Deemed Provisions – Cl 67 Matters to be considered by local Government

Comment:
Byford District Structure Plan – Refer to Report
Byford Townsite Detailed Area Plan

Complies – The following elevations are for the Fast Food tenancies, convenience store, and fuel canopy viewed from the Highway.

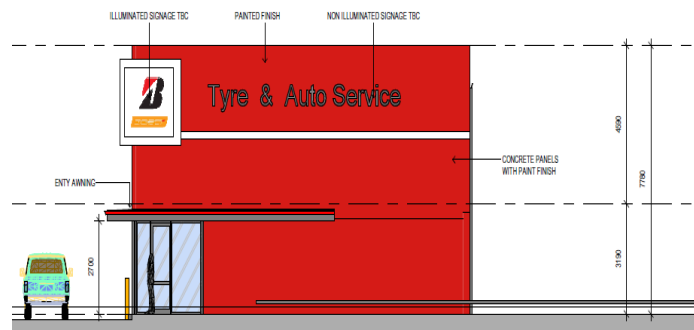
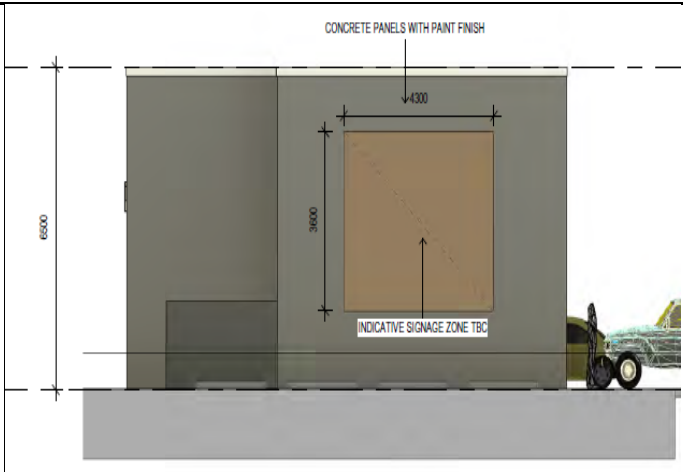
Officers consider that the Highway frontage has been adequately addressed taking into account the corporate branding required for the different tenants. The proposed cladded precast walls and timber columns and battens will improve the visual impact of the site. The coloured blank walls particularly for the convenience store will be ameliorated by the proposed timber colonnade along the edge which will further present an interesting visual aspect to this frontage. This timber feature will provide a quality presentation to Southwestern Highway.

In addition, building bulk from the proposed development will be softened by proposed landscaping adjacent to Southwestern Highway. The applicant has provided a justification stating that most of the buildings will eventually be screened by vegetation. Overall, the design elements which include the use of timber looking columns, coloured blockwork, composite cladding, with contrasting colours and varied roof forms for the fast foods are aesthetically pleasing.

2 CAR WASH ELEVATION

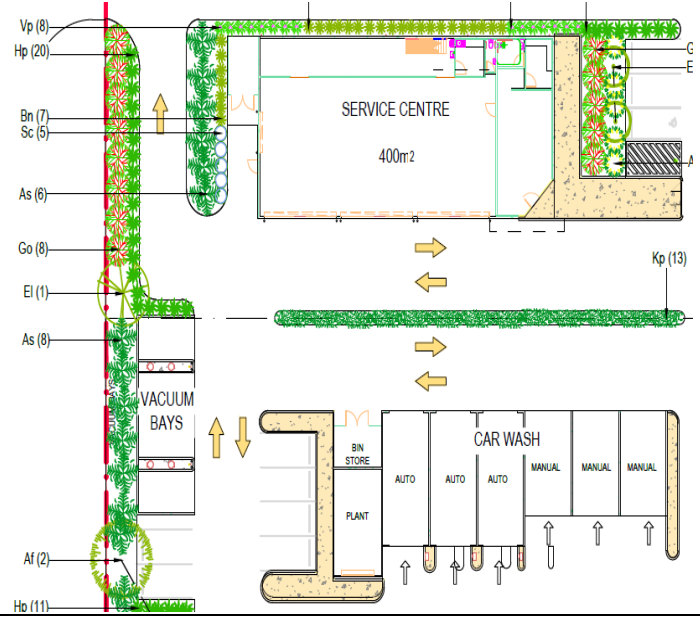
The following elevations are for the Service Center and Car wash as viewed from George Street.

Officers consider that the George Street frontage has been sufficiently addressed particularly by the proposed soft landscaping surrounding buildings facing George Street. The landscape plan indicatively includes planting of trees that will assist in breaking the building bulk as shown below:

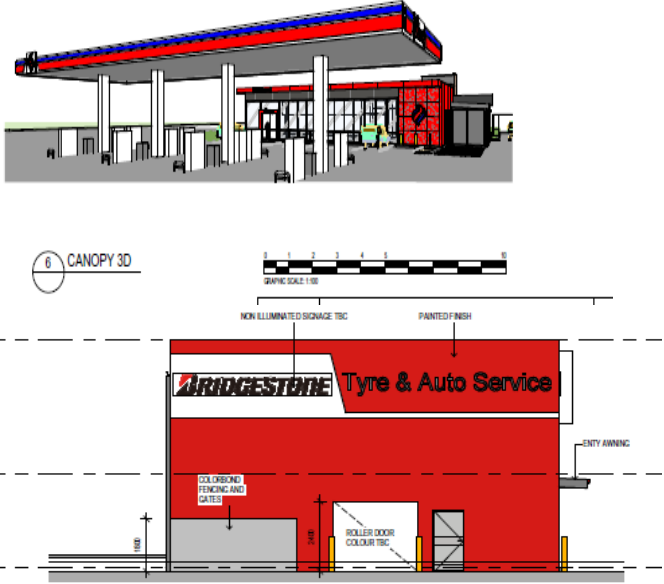
<p>Buildings should be capable of adaptation over time to cater for alternative uses.</p>	<p>Complies</p>
<p>Development may be permitted to a maximum of two storeys, with a total roof height of 8.0m maximum.</p>	<p>Complies</p>
<p><i>Building Materials and Colours</i></p>	
<p>Predominantly of brick / masonry – either rendered or unrendered, with metal (non-reflective) roofing. The use of some weatherboard cladding or custom orb profile steel sheeting as a detail feature should also be considered, in combination with the brick / masonry.</p>	<p>Complies - Tilt up concrete panel construction methods are used. The buildings are proposed to be constructed of tilt up concrete tilts.</p>
<p>Where roofing is visible, large profile roof sheeting is not acceptable</p>	<p>Complies -Roofing will predominantly be flat and hidden behind parapets.</p>
<p>The use of concrete tilt-up construction for external walls will only be permitted if the developer can demonstrate that proposed articulation, detailing and the provision of windows is compatible with the objectives and provisions of these Guidelines. Acceptable means of treating tilt-up slabs include detailing by texturing / grooving surfaces, by the use of bas-relief designs or public artworks and the inclusion of brick headers around windows and doors. Other design devices to accentuate openings may be considered.</p>	<p>Complies -Design and style is in keeping with the semi-rural character of the Byford area. Verandah style and façade treatment below sufficient to address this issue.</p>  <p>6 PERSPECTIVE</p>
